Memorandum Planning and Urban Development Department Planning Division

To: Chair Boepple and Members of the Portland Planning Board
From: Jean Fraser, Planner
Date: February 5th, 2016
Re: **February 9th Planning Board Workshop**
Level III Subdivision and Site Plan:
Redevelopment to create 4 residential units, 31 Fore Street
Bob and Carrie LeBlanc, Peninsula Property Development, Applicants

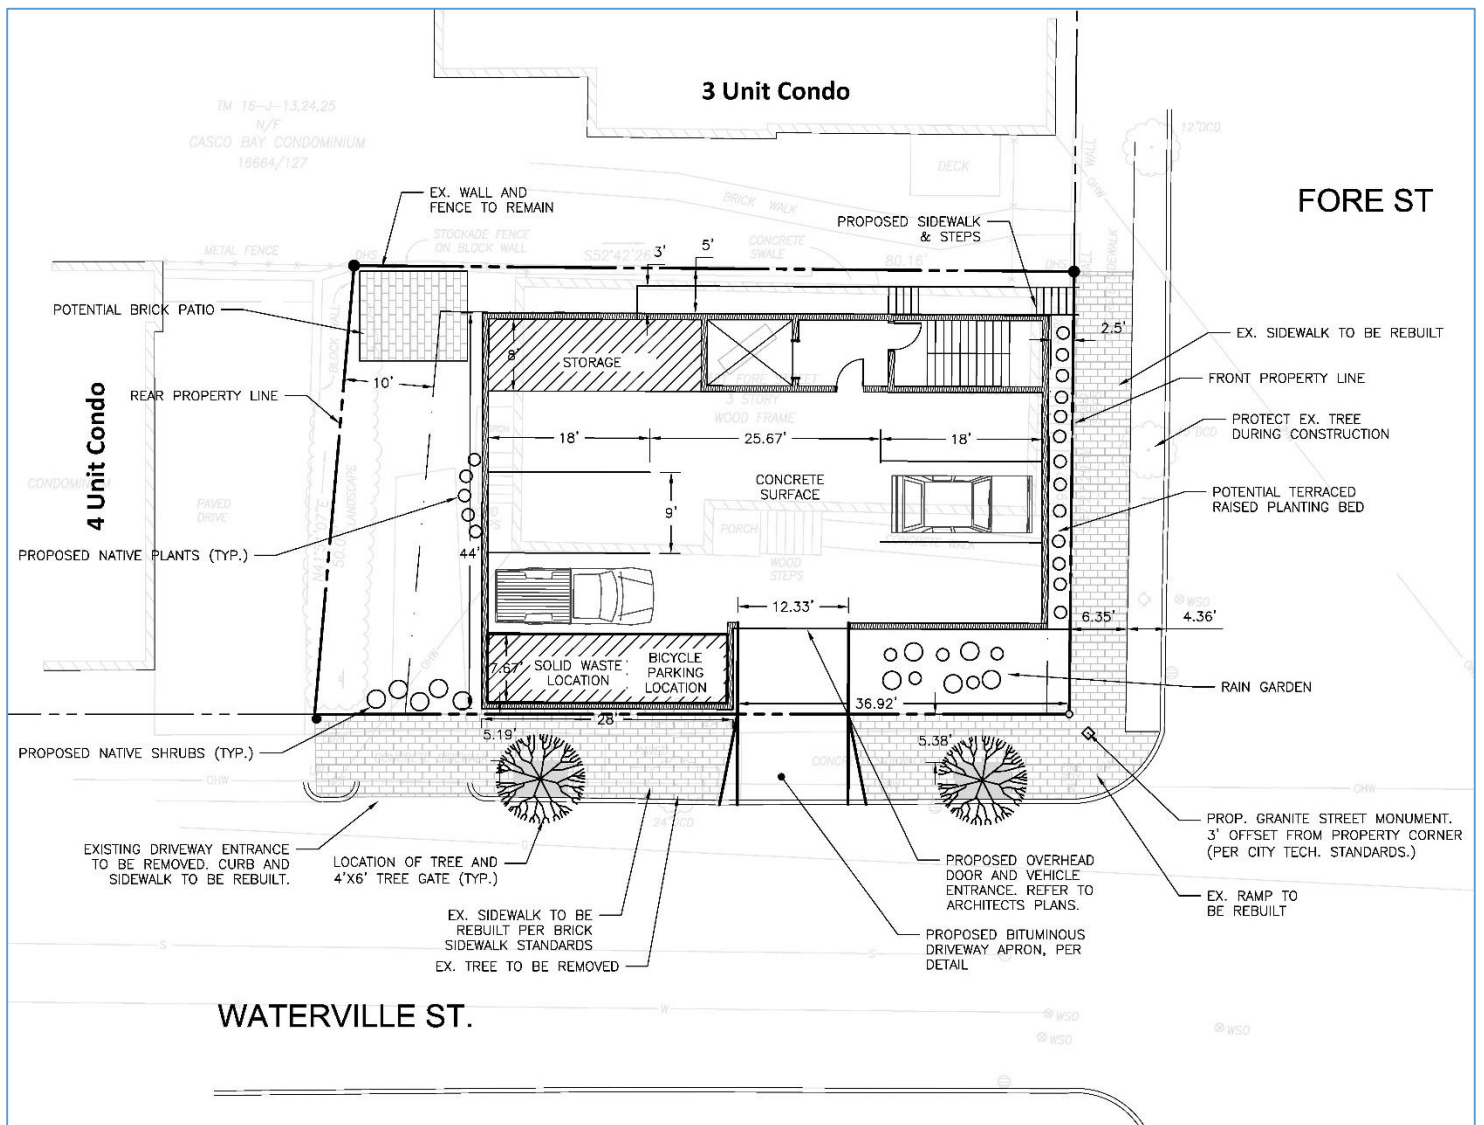
The hatched area on the plan below denotes the location of a second set of stairs which the applicant understands may be needed to meet building codes. This has been questioned by staff as it has implications for required setbacks as discussed below and in Sections VI A. *Zoning* and VI C 4. *Site Design Standards*.

The area for the second set of stairs is shown hatched on the floor plans (Plan P8). Staff have questioned the need for a second set of stairs (between the elevator and the rear wall) as this affects whether the project is compliant with zoning.

Assistant Fire Chief Keith Gautreau has confirmed (Attachment 2) that since the building is proposed to be sprinkled and is 4 stories or less, the Fire Codes allow a single means of egress and the second set of stairs is not required. However, under Building Codes the second set of stairs would be required if the building is considered to be 4 stories as defined in the IBC, and not required if the building is defined as 3 stories. The definition of a story relates to the extent to which it is below final grade and the applicant has been requested to provide the relevant calculations in order to establish the number of stories.
